UNITED STATES PATENT AND TRADEMARK OFFICE

APPLICATION NO.	FILING DATE	FIRST NAMED INVENTOR	ATTORNEY DOCKET NO.	CONFIRMATION NO.
10/824,248	04/14/2004	Dragan Veskovic	LUTR-0241/03-055 P2	6423
23377	7590	12/13/2005	EXAMINER	
WOODCOCK WASHBURN LLP ONE LIBERTY PLACE, 46TH FLOOR 1650 MARKET STREET PHILADELPHIA, PA 19103			VO, TUYET THI	
			ART UNIT	PAPER NUMBER
			2821

Office Action Summary

DETAILED ACTION

FIG. 1

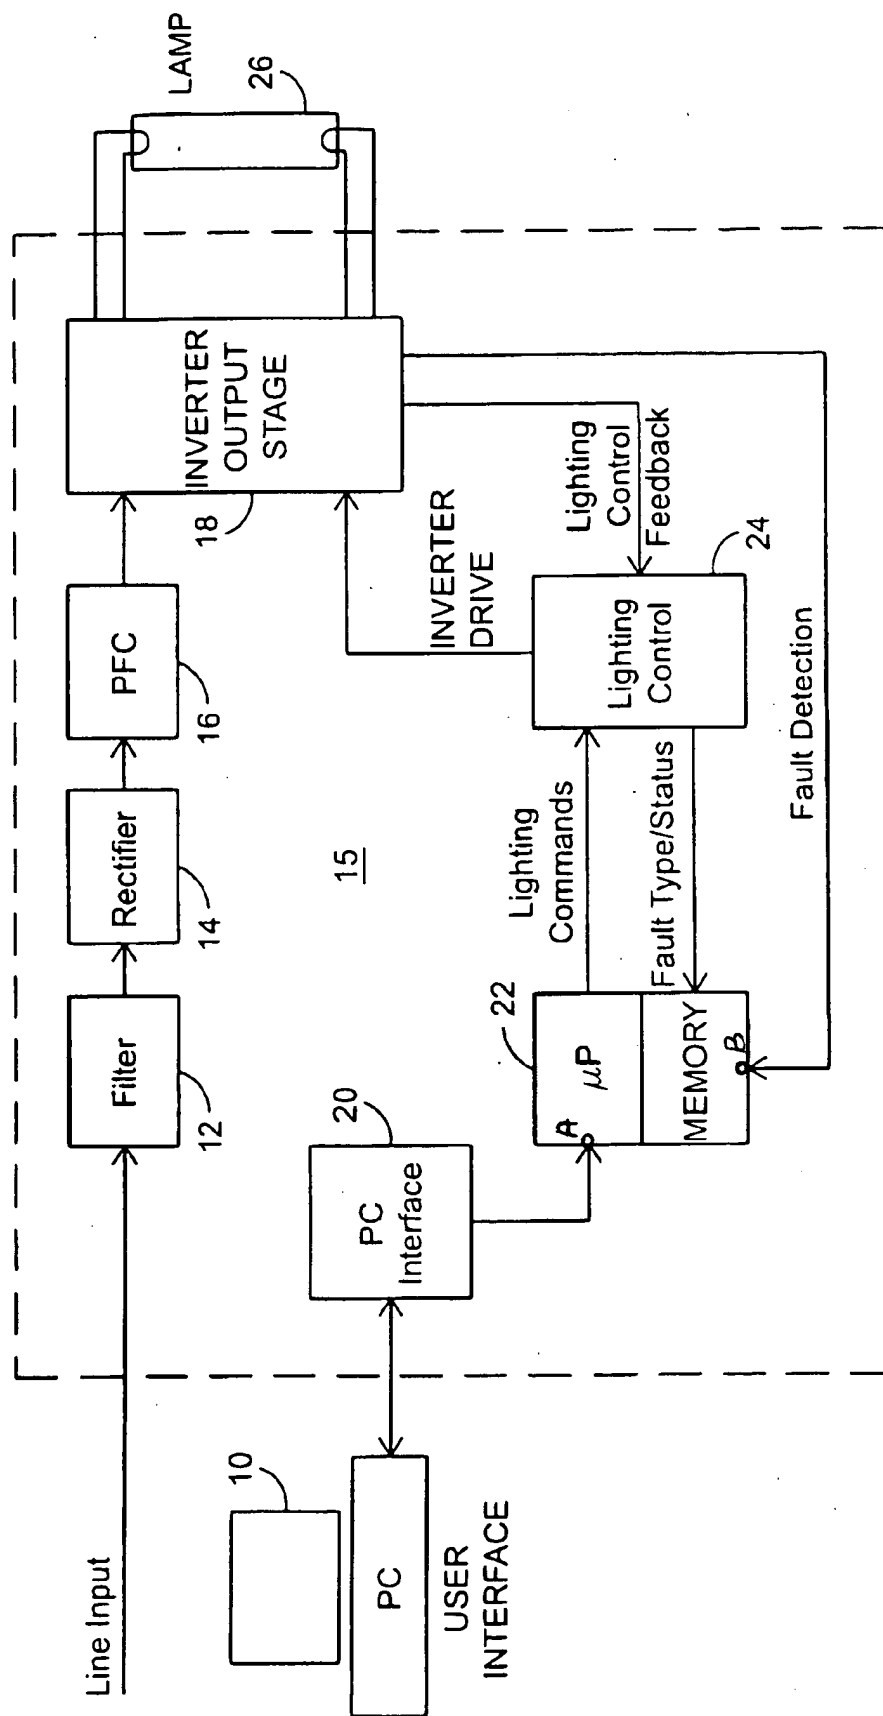
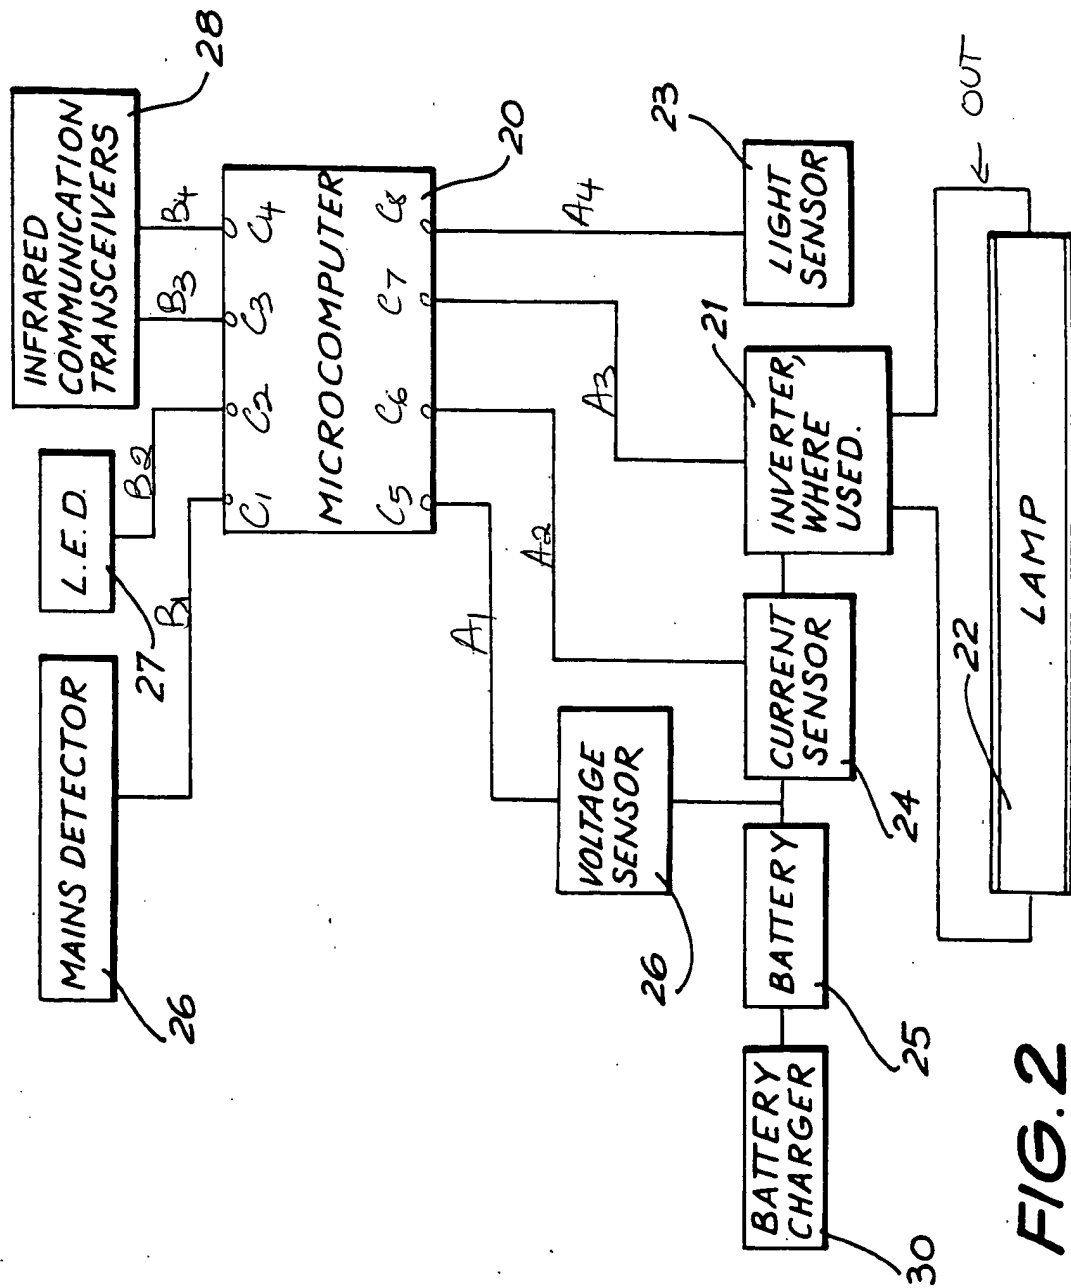
Regarding claims 1-5, 8, 10-15 and 18, 20-24, Helal discloses an apparatus and method as well for gas discharge lamp (Fig. 1-4) comprising:

a microcomputer (20) for controlling a level of a ballast output signal (OUT, marked by examiner) for gas discharge lamp (22) in response to a plurality of ballast control signals (A1-A4, B1-B4, marked by examiner);

an inverter (21), inherently/conventional having at least one switch, for receiving a processor output signal (A3) from said microcomputer (20) and providing said ballast output signal (OUT) in response to said processor output signal (A3); and

a plurality of input terminals for receiving said plurality of ballast control signals (C1-C8, marked by examiner); wherein at least one of said plurality of input terminals (B3, B4) is a bidirectional terminal capable of receiving and sending control signals for communicating between the microcomputer and infrared communication transceiver (28).

Ribarich discloses an electronic ballast for driving a gas discharge lamp (Fig. 1), comprising

an inverter circuit (18, 24) producing a high frequency drive voltage for driving a lamp current in the gas discharge lamp;

a microprocessor (22) connected to said inverter circuit (18, 24); said microprocessor directly controlling said inverter to control said lamp current to a desired level;

ports (A, B, marked by examiner) connected to said microprocessor for receiving a message/command and providing said message/command to said microprocessor;

FIG. 4

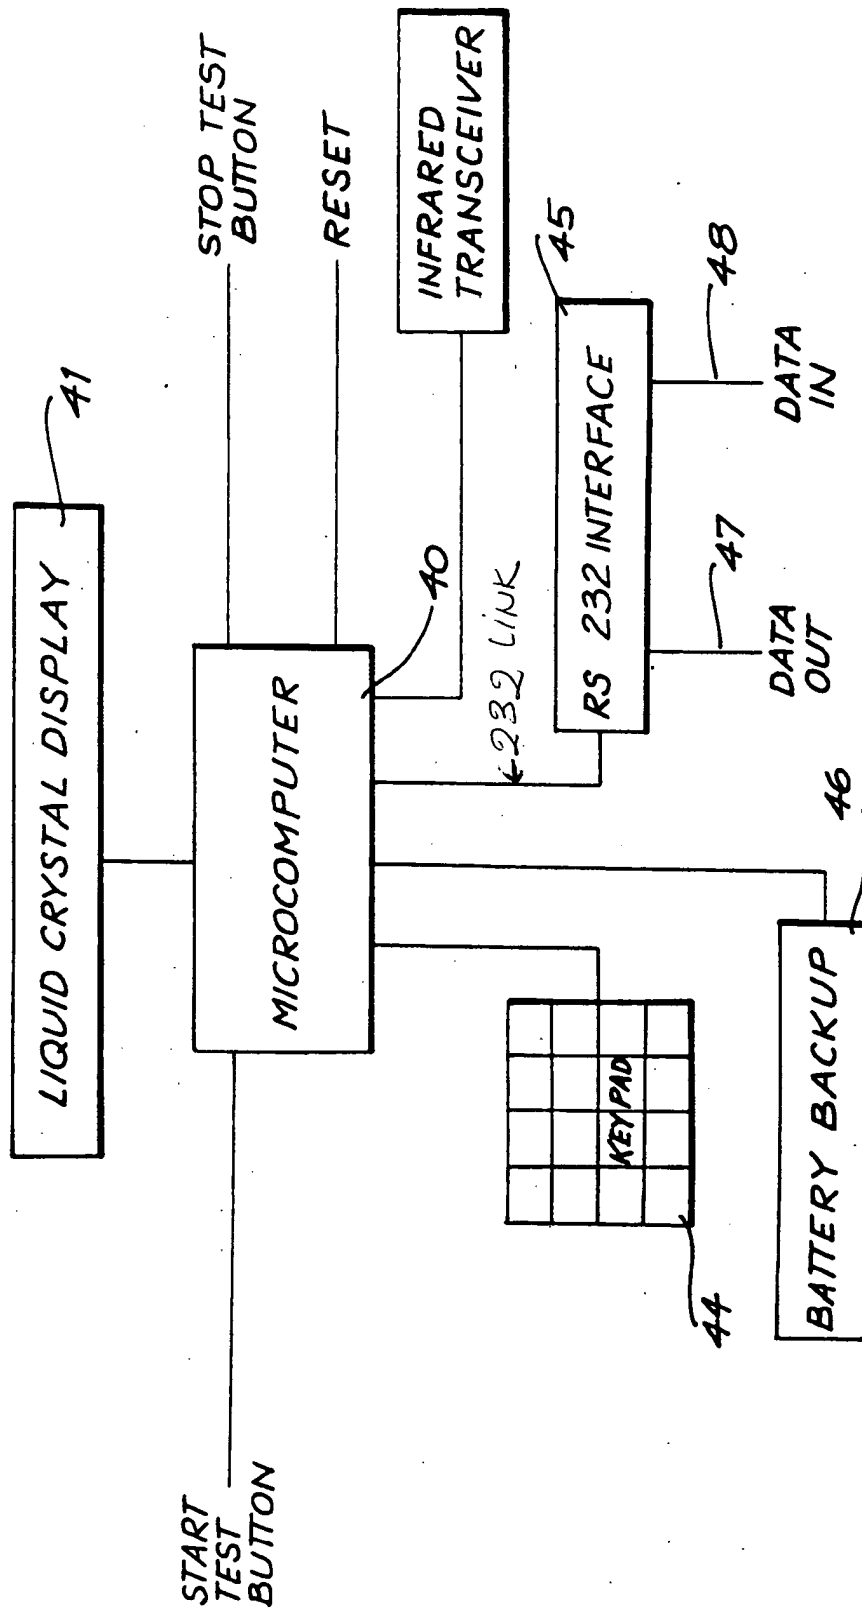
A port in electrical communications (45) with the microcomputer (Fig. 4) for sending message comprising at least one of command and ballast configuration (col. 8, lines 37-42), wherein the port (45) having one of receiving message (232-LINK, marked by examiner) and both receiving (47) and sending message (48). The microcomputer contains a program for responding to a message received via the port by sending a message via the port (Figs. 4 and 5).

at least one port (C1-C8) connected to said microprocessor for receiving a message and providing said message to said microprocessor, wherein a memory included in microprocessor; and a set of data stored in said memory for carry automatic self test, program test and other for controlling the lamp level in an emergency, said microprocessor being adapted to change a portion of said set of data in response to receiving a predetermined message via a Key pad or other sensing signals (voltage sensor, current sensor, light sensor, IR transceiver)
